**Re: Newfoundland and Labrador Hydro - Reliability and Resource Adequacy Study Review - The Liberty Consulting Group Summary of and Comments on Labrador Island Link Study Reports Issued in April 2020**

**Summary of and Comments on  
LIL Study Reports  
Issued in April 2020**

**The Liberty Consulting Group**

**June 9, 2020**

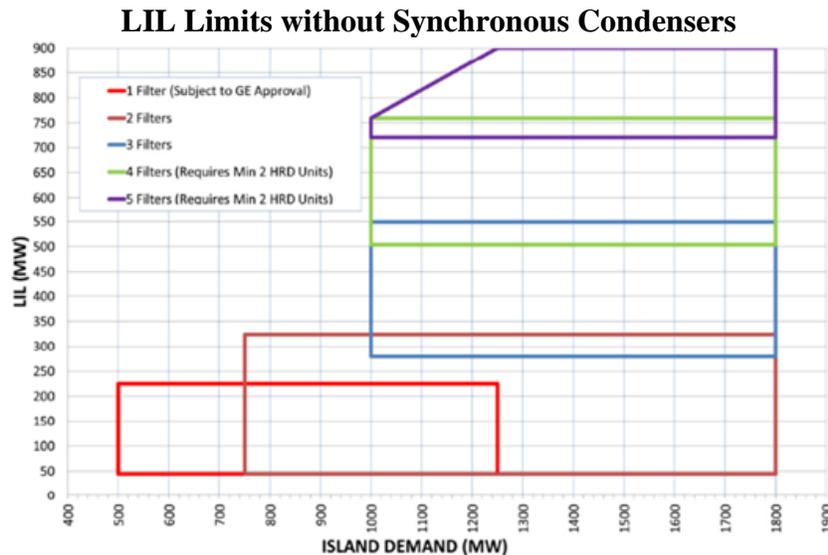
*Harmonic Filters* - - AC harmonic filters reduce to an acceptable level the harmonic distortion that operation of the HVDC converters will produce. These filters are switched in and out as the power on the LIL is increased and decreased, in order to control the ac voltage. Harmonic analysis by TGS has determined that the LIL can operate up to its full 900MW capability with just two filters. However, this assessment considers only harmonics. Reactive power/ac voltage control considerations produce a need for five in-service filters to support LIL operation at 900MW, to provide sufficient system voltage support.

Switching in a filter causes the voltage to rise. The ac voltage drops when switching out the filter. The voltage step resulting from the switching of a filter depends on the strength of the network (its short circuit level, or "SCL"). The SCL increases with more generation or synchronous condensers in service. Applicable planning criteria prescribe voltage step limits, which depend on the number of switching operations per day. With no synchronous condensers available, at least one Holyrood generating unit must be in service to permit switching the first two filters into service. Switching a third filter into service requires two Holyrood units in service. Five filters require all three Holyrood generating units in service. TGS found that having one synchronous condenser in service produced no violation of voltage step limits, even with no Holyrood generating units available.

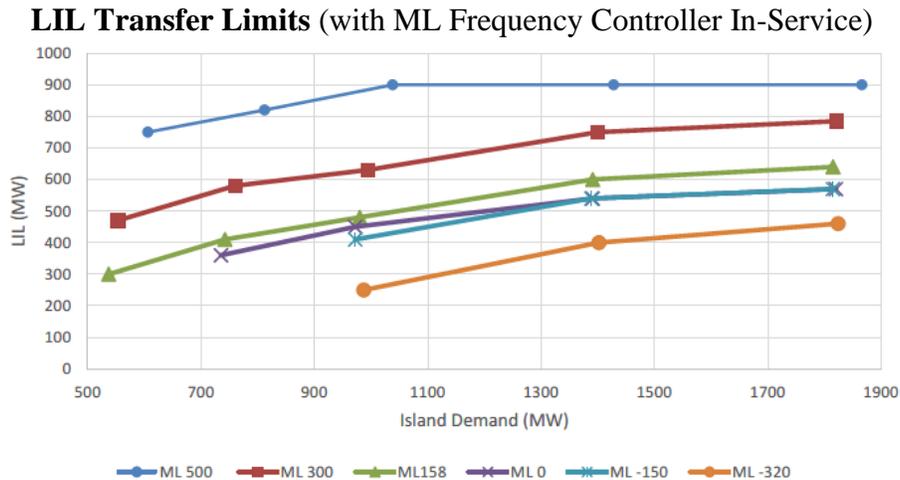
Critical determinants of maximum permissible LIL loads (to ensure that loss of one pole will not cause IIS frequency to drop below 59 Hz or produce UFLS) include:

- Loads on the IIS
- Whether and how much the ML is exporting or importing
- Whether the ML frequency controller is in service.

The analysis performed assumed the ability to run-back exports or imports on the ML is always available.

**LIL Transfer Limits (with ML Frequency Controller Not In-Service)**

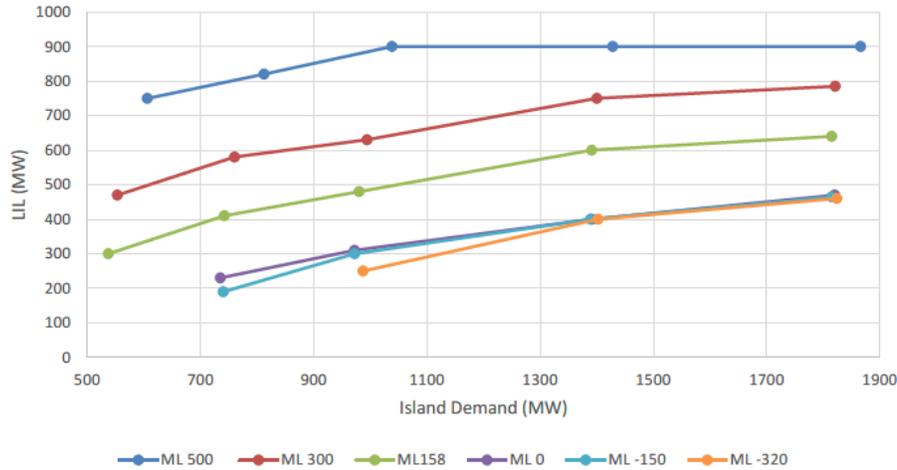
The next two figures show these LIL transfer limits as a function of demand on the IIS, considering the factors controlling them. The colored lines show these LIL limits at varying ranges of ML operation, from exporting 500MW (blue) to importing 320 MW (orange). The figures demonstrate, as expected, that the LIL’s ability to bring power to the IIS depends heavily on the magnitude and direction of power flow on the ML. The impact of ML frequency control, which may not always be available, also affects maximum power flows.
